Work Order ID 151500

DART SERVICE INSTRUCTION

TO AMEND INSTALLATION INSTRUCTIONS D350-567 REV. E
AND INSTRUCTIONS FOR CONTINUED AIRWORTHINESS ICA-D350-567 REV. 2

REF. TCCA STC: SH92-18

EDIT 5.0/25.7 PARTS LIST:

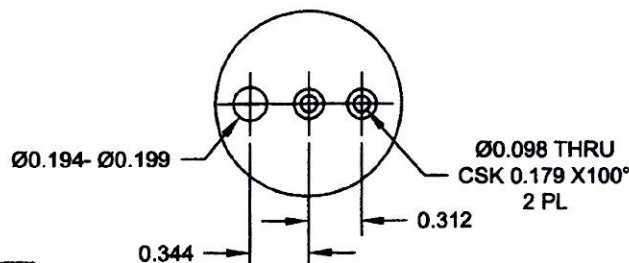
For customers with kits D350-567-013/-015/-017/-023/-025/-027/-117 @ CHG002 and earlier,
Customers with kits D350-567-111 @ CHG006 and earlier,
Customers with kits D350-567-115 @ CHG004 and earlier,
Customers with kits D350-567-031/-031B/-111B/-115B @ CHG001 and earlier,
Procure kit DSI 9745-011

For customers with kits D350-567-013/-015/-017/-023/-025/-117 @ CHG003 and later,
Customers with kits D350-567-111 @ CHG007 and later,
Customers with kits D350-567-115 @ CHG005 and later,
Customers with kits D350-567-031/-031B/-111B/-115B @ CHG002 and later,
Refer to Installation Instructions D350-567 and ICA-D350-567 and update the parts list as follows:

FIGURE 1

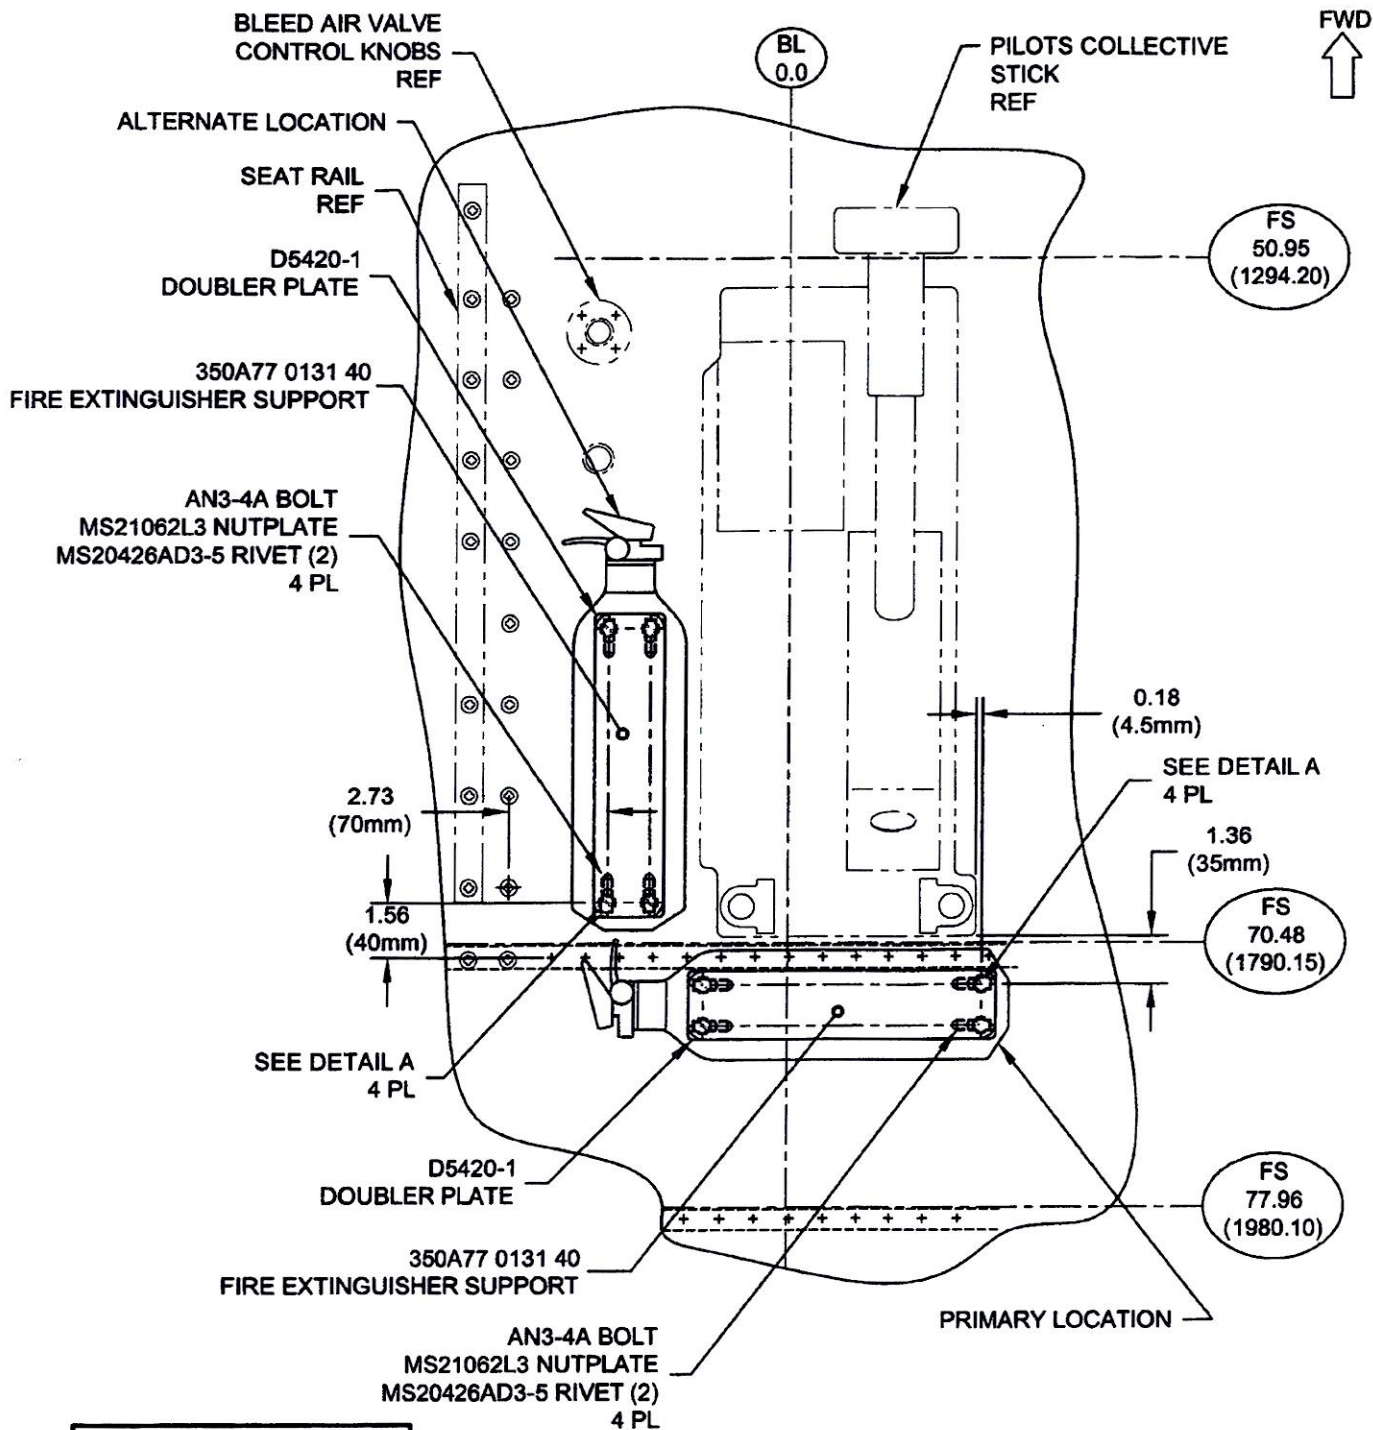
For aircraft equipped with P/N 19810-02-00 (SICMA-198 Seat) add section 3.2.3, amend section 5.0 Parts List (ICA Section 25.7) and amend section 4.0 Weight and Balance (ICA Section 25.5) of Vertical Reference Window Installation Instructions D350-567 Rev. E (ICA D350-567 Rev. 2) as follows:

- (ADD) 3.2.3 This installation will require access to the under floor structure in the area aft of the pilot's collective stick. To access the under floor structure remove the applicable belly panel in accordance with the applicable Aircraft Maintenance Manual.

Remove and retain the cabin fire extinguisher P/N 1708337 B4 and Fire Extinguisher Support P/N 350A77 0131 40 from existing location. Per Figure 1, select the desired location for the fire extinguisher at either the "Primary" location or "Alternate" location.

Locate the D5420-1 Doubler Plate at the selected location per Figure 1 and transfer mark the holes from the D5420-1 Doubler Plate to the aircraft floor. Drill the nutplate hole pattern shown in Detail A. Touch up the drilled floor surface finish with chemical film (Alodine 1200/1201) per MIL-C-5541 and one coat of MIL-P-85582 or MIL-P-23377 primer.

Locate the D5420-1 Doubler Plate under the floor and install using qty (4) MS21062L3 nutplates and qty (8) MS20426AD3-5 Rivets (rivets fasten through floor and doubler). Locate the Fire Extinguisher Support P/N 350A77 0131 40 over the drilled holes and fasten it to the qty (4) MS21062L3 nutplates using qty (4) AN3-3A Bolts. Torque bolts 20-25 in-lbs (2.3-2.8 N-m). Reinstall the P/N 1708337 Fire Extinguisher per the Aircraft Maintenance Manual.
